SUBJECT: Entergy Operations, Inc.
Relaxation Request to NRC Order EA-03-009 for Control Element Drive Mechanism Nozzles

Arkansas Nuclear One, Unit 2
Docket No. 50-368
License No. NPF-6

CORRECTED TABLE AND FIGURES

Figure 8: *Plot showing hoop stress distribution along tube axis for the 0° nozzle. The top of compressive zone, the reference line, and the bottom of the weld are shown.*

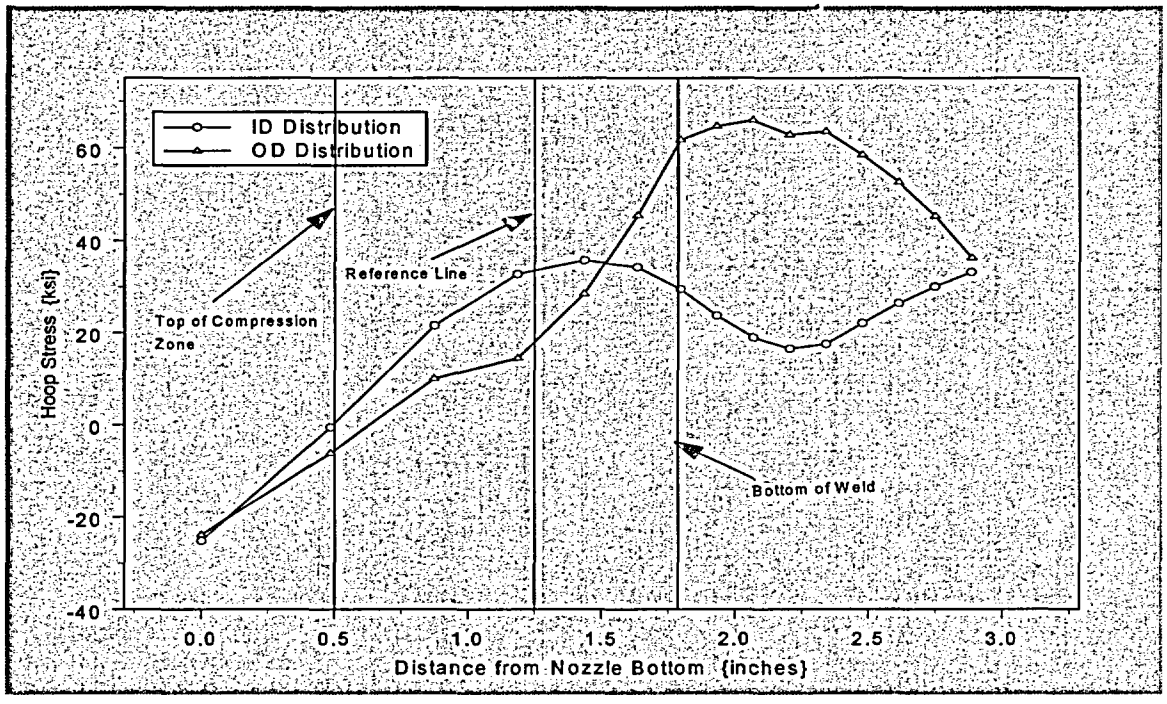
Since submitting Relaxation Request #1, Entergy has discovered typographical errors in the request and in the supporting Engineering Report M-EP-2003-002, Rev. 1. Specifically, Table 2 of Relaxation Request #1 was mislabeled and Figures 8 through 11 and 15 of the engineering report contained mislabeled reference lines. These corrections do not impact any technical information or conclusions of the report. A corrected table and corrected figures are provided in Enclosure 1. These supercede the previous table and figures.
